Thank you for your completeness review comments for the Pier 70 Parcel A development on August 18, 2019. The design team has made necessary changes or provided additional information where necessary. The sheets referenced below correspond to where these changes have been made.

PIER 70 PARCEL A - DESIGN REVIEW

BROOKFIELD PROPERTIES
PIER 70 PARCEL A

CLASS A BICYCLE PARKING - LIFT ASSIST DERO DECKER (4 BIKES PER UNIT)

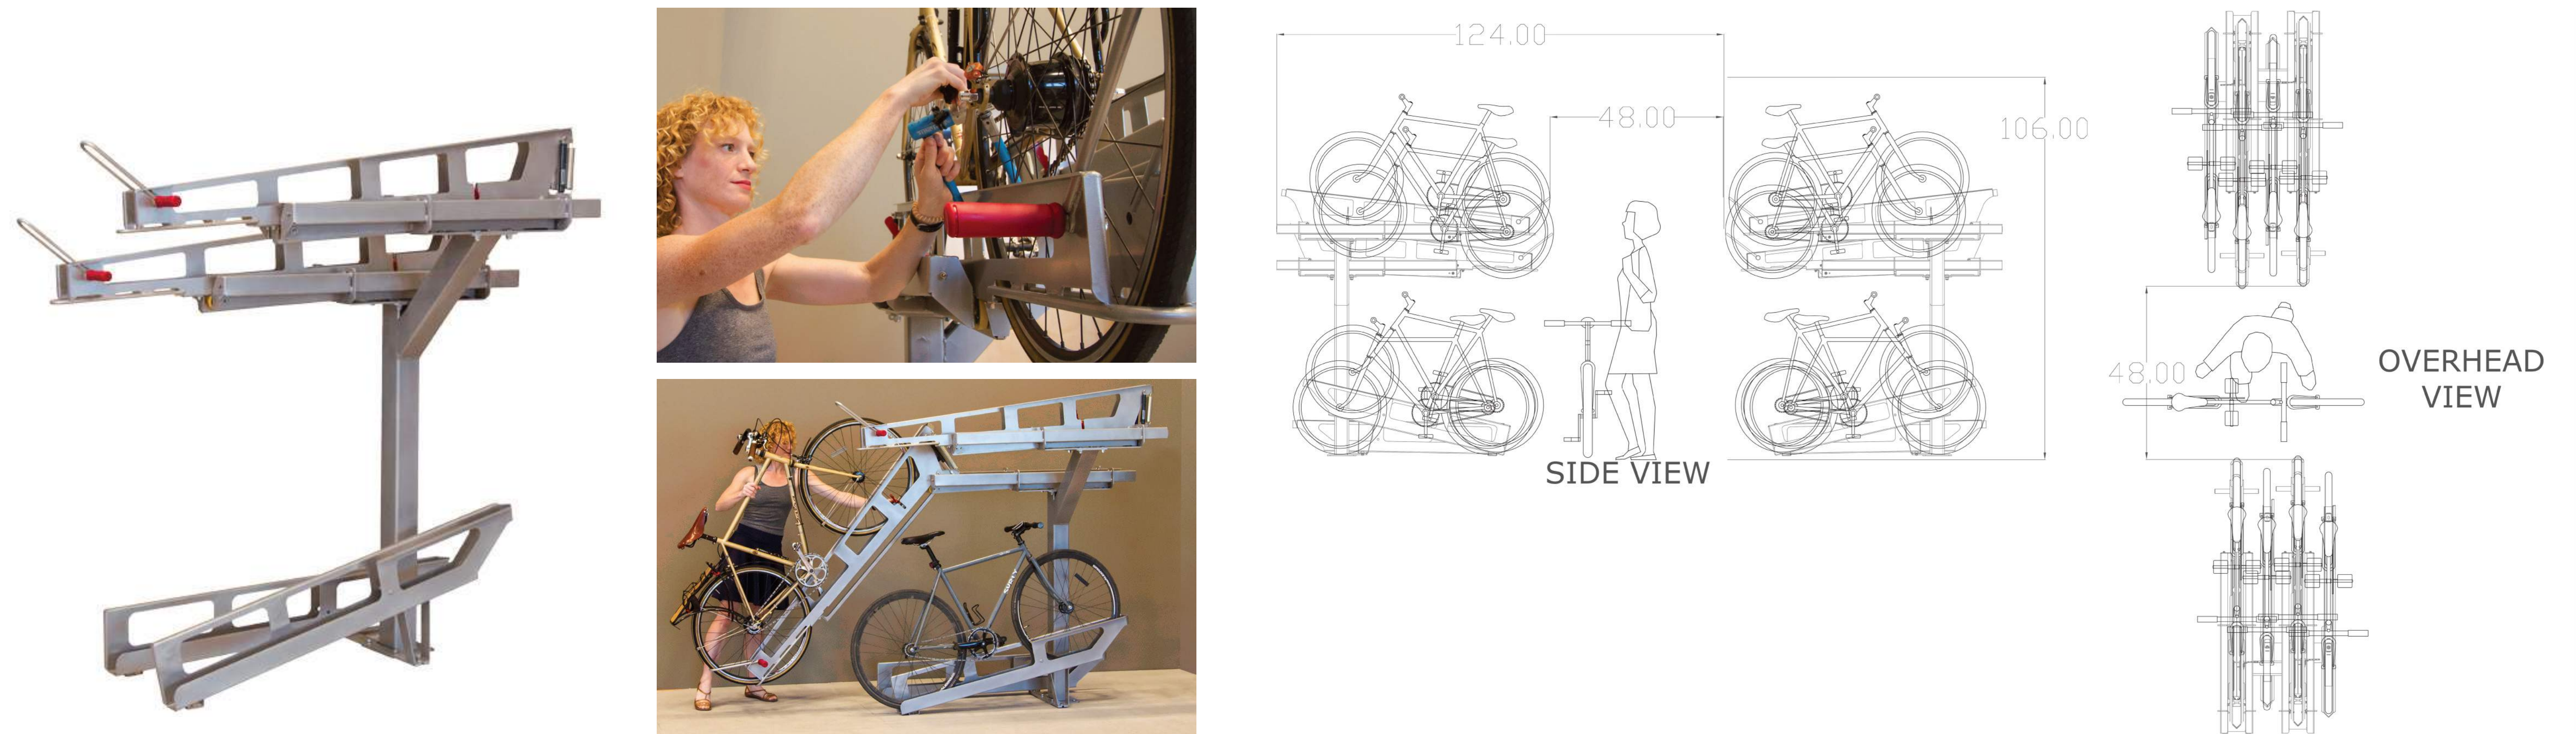
- i. **Sheet A-060** Site plan – Class 2 bicycle parking spaces identified
- ii. **Sheet A-060** Site plan – Bicycle repair station location identified
- iii. **Sheet G-001.9** Zoning Narrative – Detail on Class 1 bicycle parking systems

SITE PLAN AND GRADING

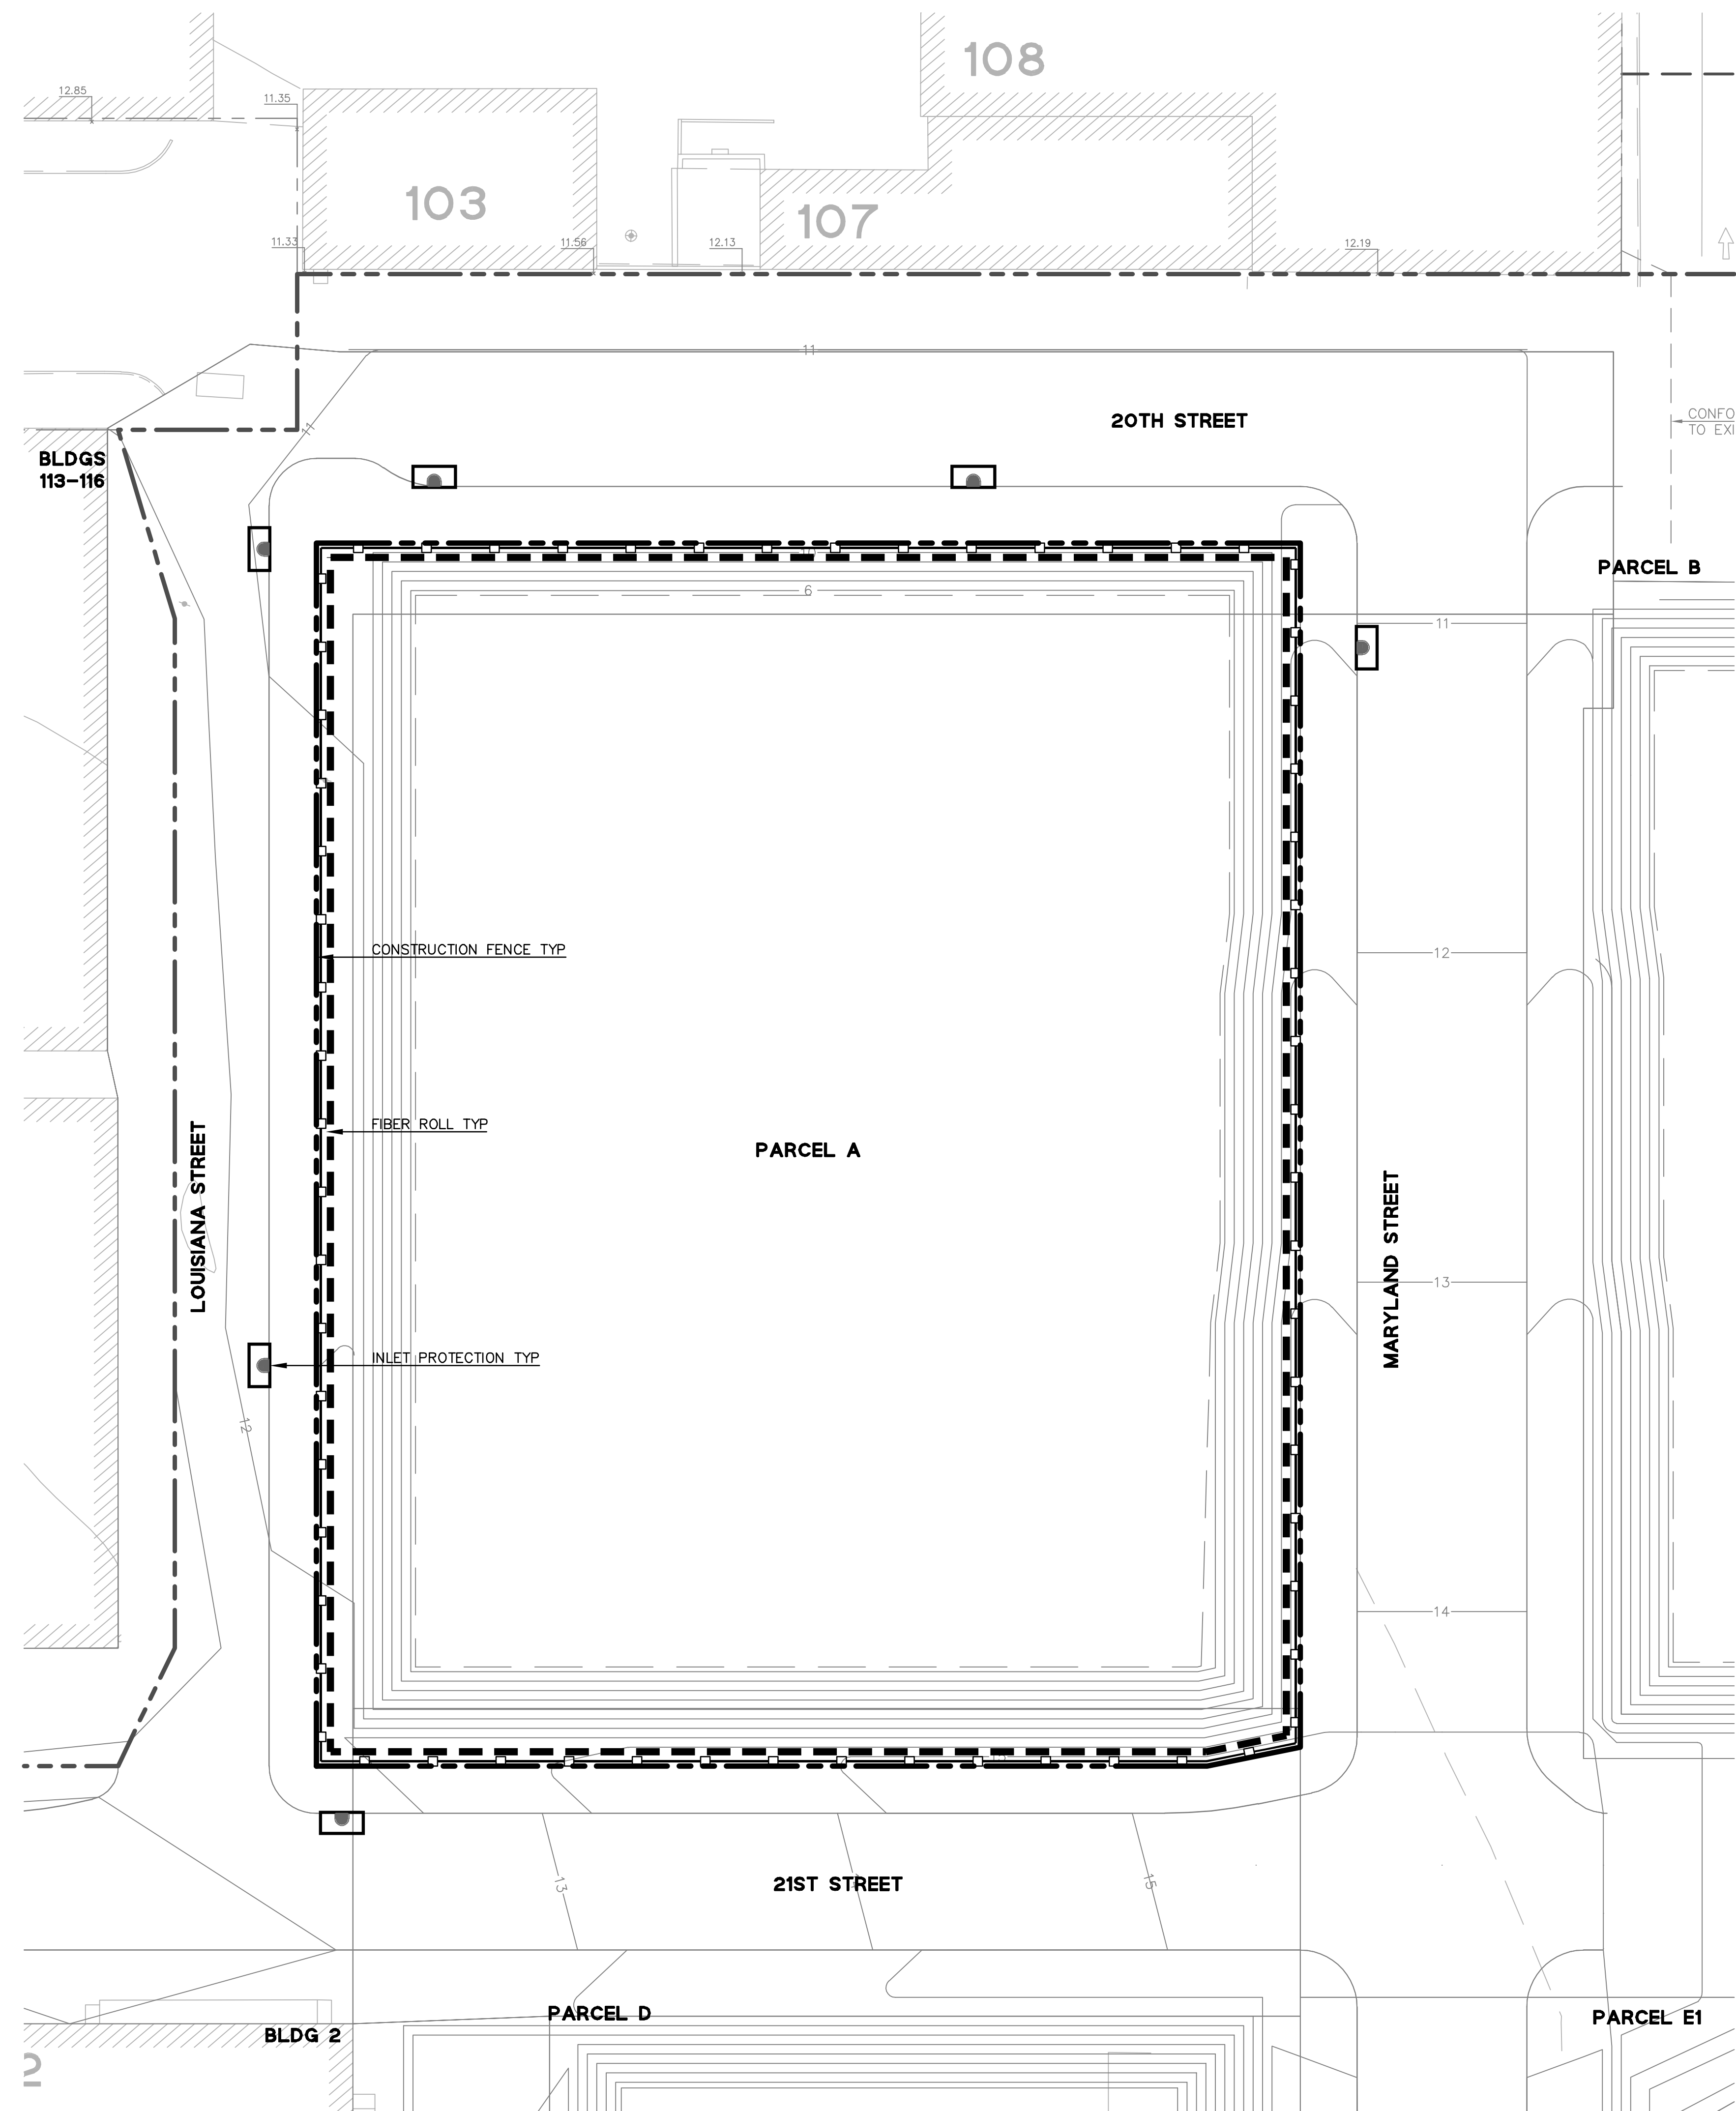
b. Curb Cuts: **Sheet C-02** – See note on C-02 – details for driveways are included in the Pier 70 SUD Phase 1 Improvement Plans, Permit 19IE – 00245.

NOTE:
DETAILS FOR IMPROVEMENTS ON FRONTAGES, INCLUDING BUT NOT LIMITED TO CURB AND GUTTER, DRIVEWAYS, SIDEWALKS, ETC. ARE INCLUDED IN THE PIER 70 SUD PHASE 1 IMPROVEMENT PLANS, PERMIT 19IE-00245.

DRAWING TITLE
LEVEL 1 FLOOR PLAN

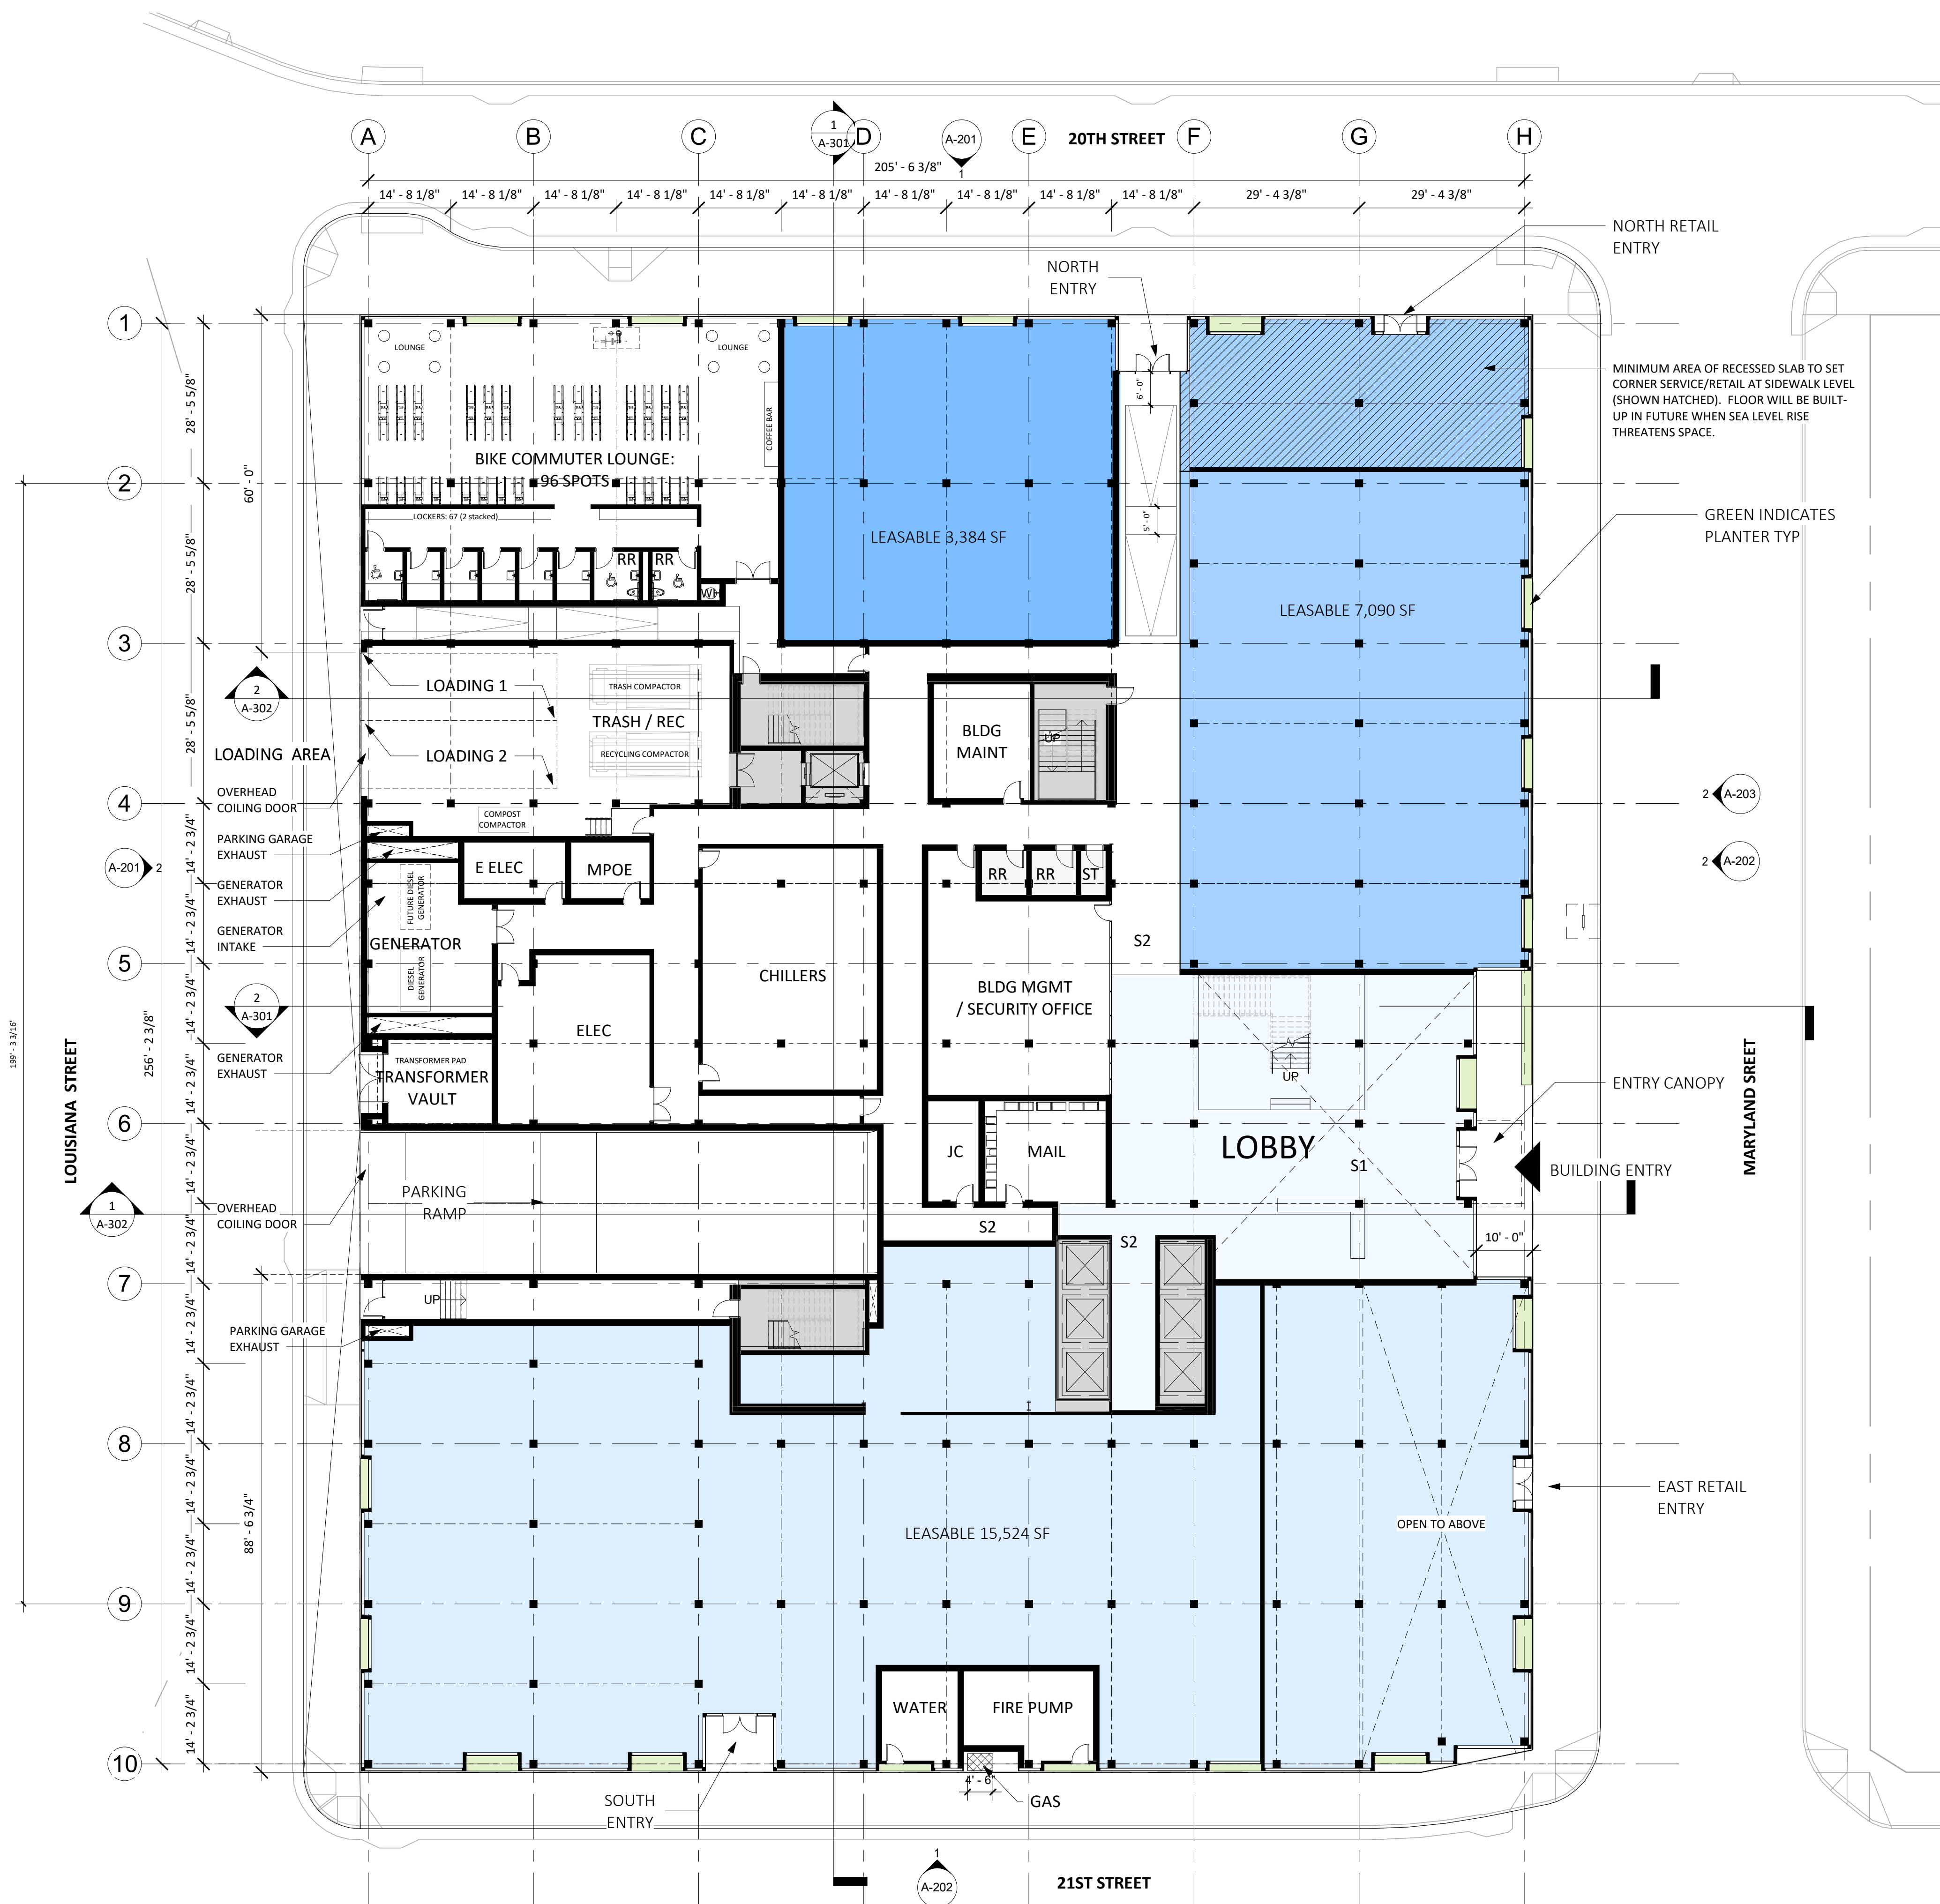
- c. Parking: **Sheet A-100** – Parking count breakdowns by what is required and proposed has been provided.
- 3. Transition Strips (D4D Ch. 5.6)
 - a. **Sheet A-303** - Driveway slope and transition strips have been dimensioned.
- 4. Long Façade in Key Locations (D4D Ch.6.18)
 - a. **Sheet G-003.4 – G-003.5, Sections B-C** Massing and modulation calculations and diagrams have been updated so that no architectural strategy is considered for both massing and modulation credits.
 - b. **Sheet G-003.4, Sections C** – Amount has been updated
 - c. **Sheet G003.4-G003.5, Section D** – Material areas for calculation have been dimensioned.
